PITT-02-19-019

**Re: Sunoco Pipeline L.P. – Pennsylvania Pipeline Project (Mariner East II)
Chapter 102 Permit No. ESG0500015001 – Major Modification
Modification Request for Reroute and Installation Method Change at Goldfinch Lane and
William Penn HDDs
Jackson Township, Cambria County, PA**

Sunoco PPP-Goldfinch Major Modification

DATE: 2/6/2017
PROJECT NO.: 112C05958
DESIGNED BY: JB
DRAWN BY: BH
CHECKED BY: RS
COPYRIGHT TETRA TECH INC.
ES-2.17
SHEET 2.17 OF 102

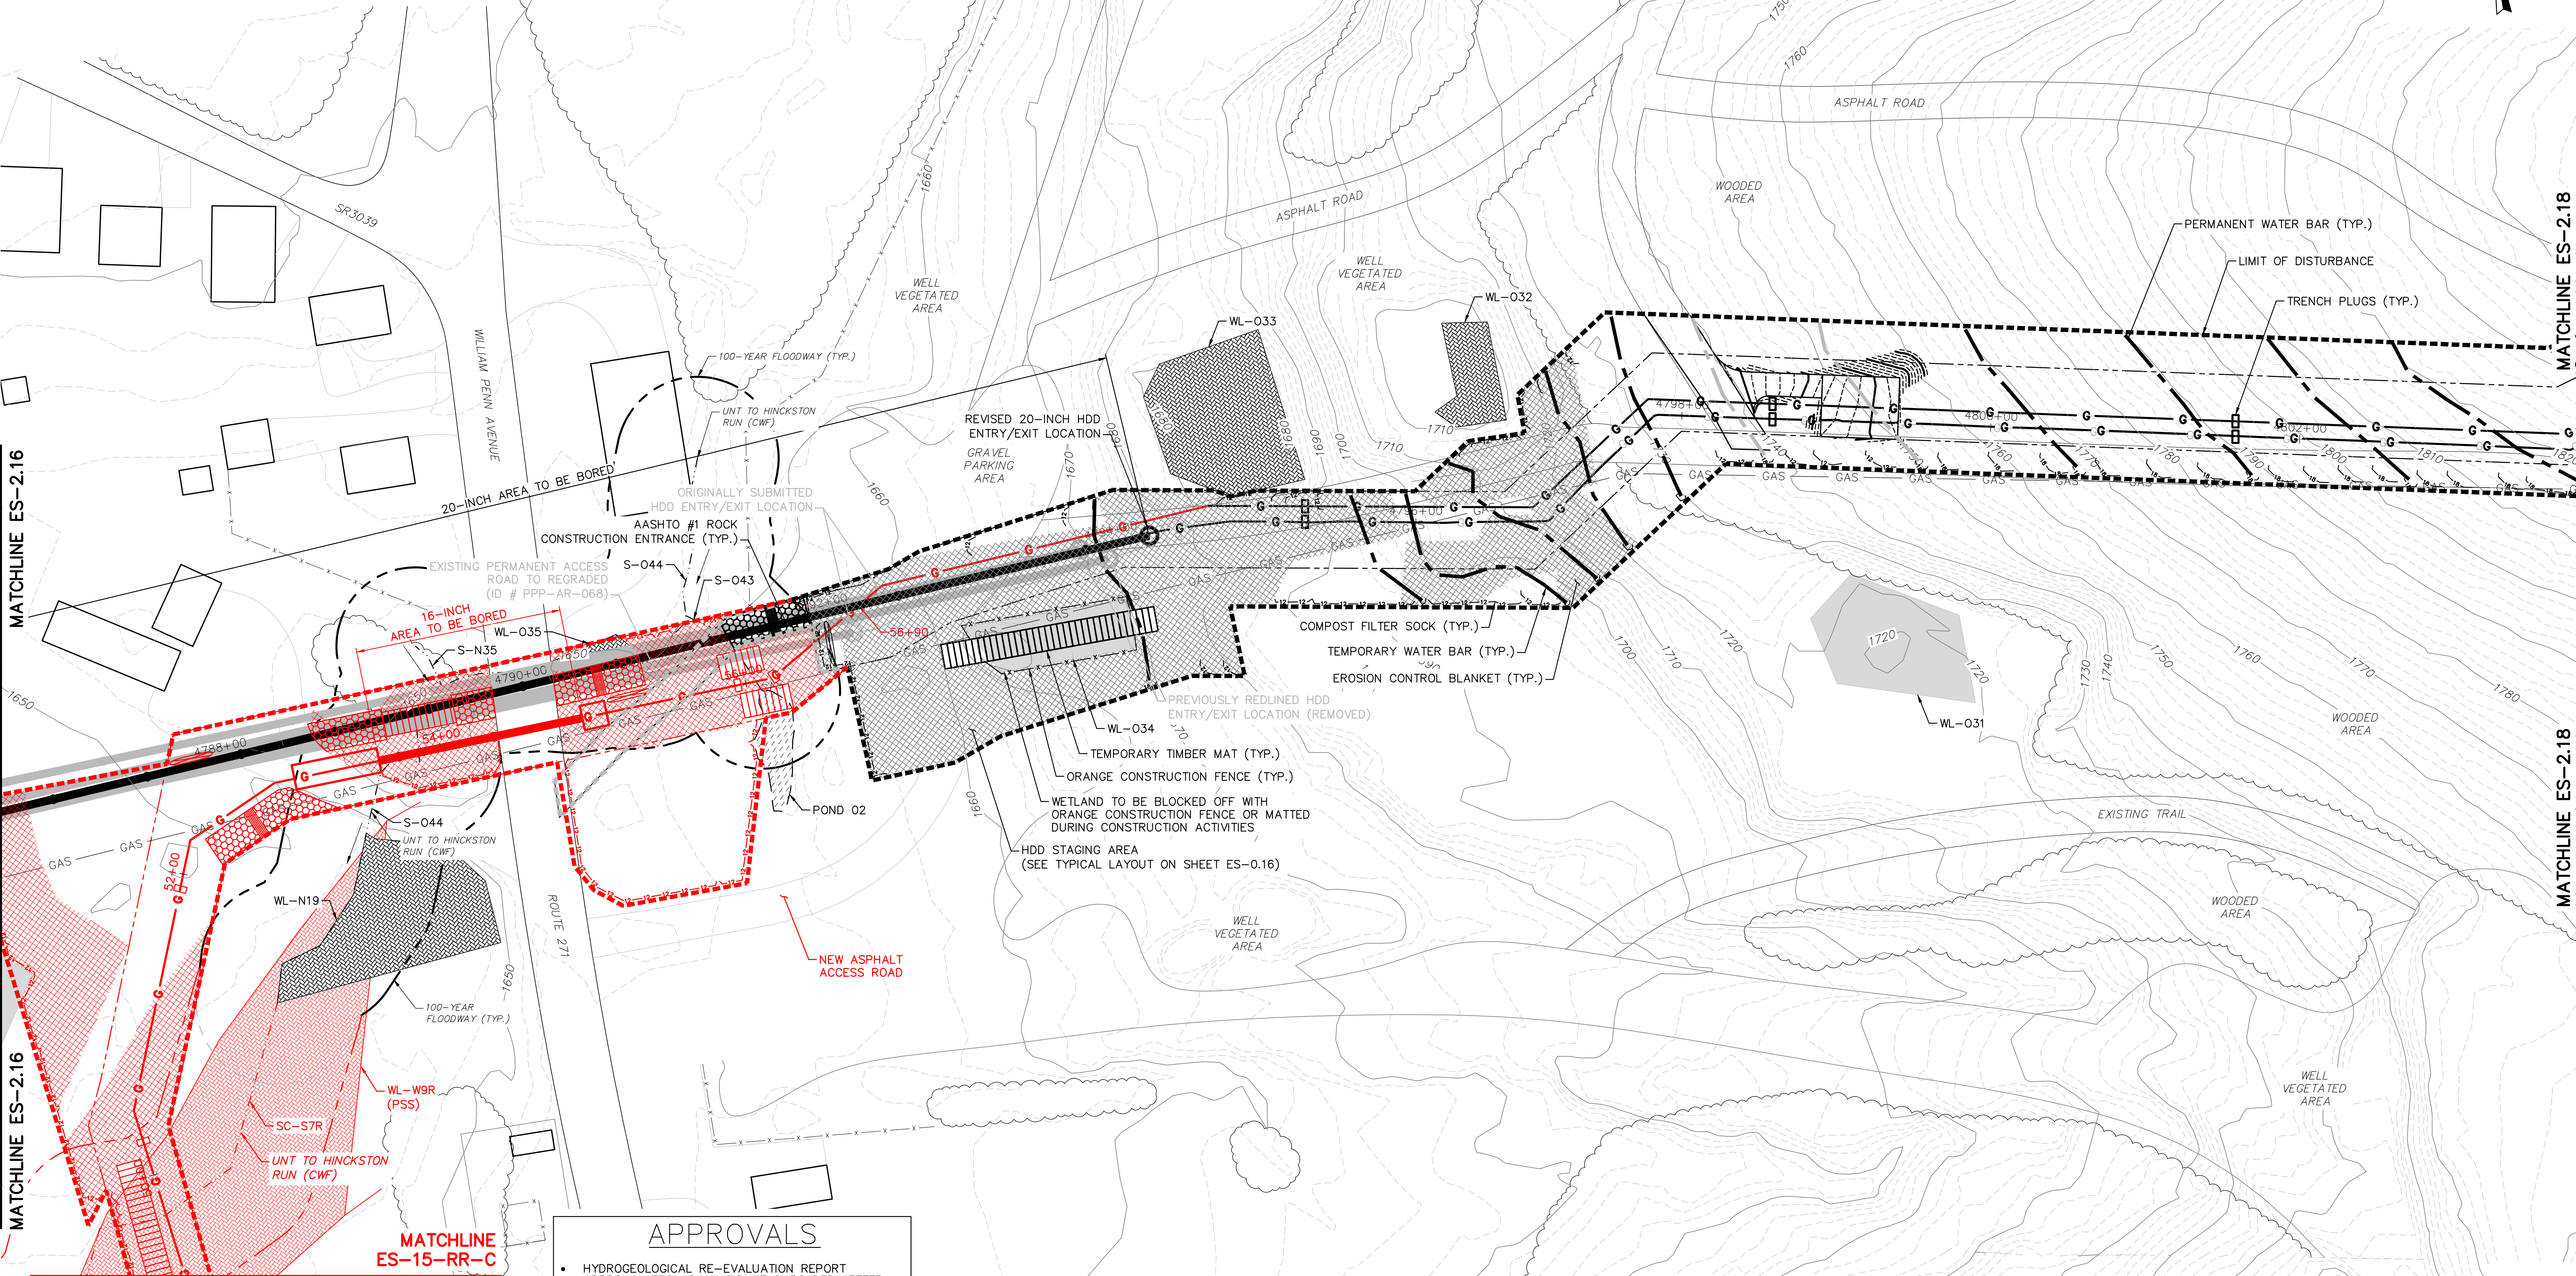
NO.	BY	DATE	REMARKS
1	RS	3/28/17	INCORPORATED THE SPECIAL CONDITIONS SET FORTH IN DEP'S CHAPTER 102 AND CHAPTER 105 PERMITS
2	RS	5/25/17	DRAWINGS PROVIDED TO FIELD
3	RS	5/21/18	WILLIAM PENN AVE REVISED HDD
4	RS	10/2/18	RELOCATED WILLIAM PENN AVE BLOCK VALVE
5	RS	1/11/19	16" RE-ROUTE & BORE ADDED
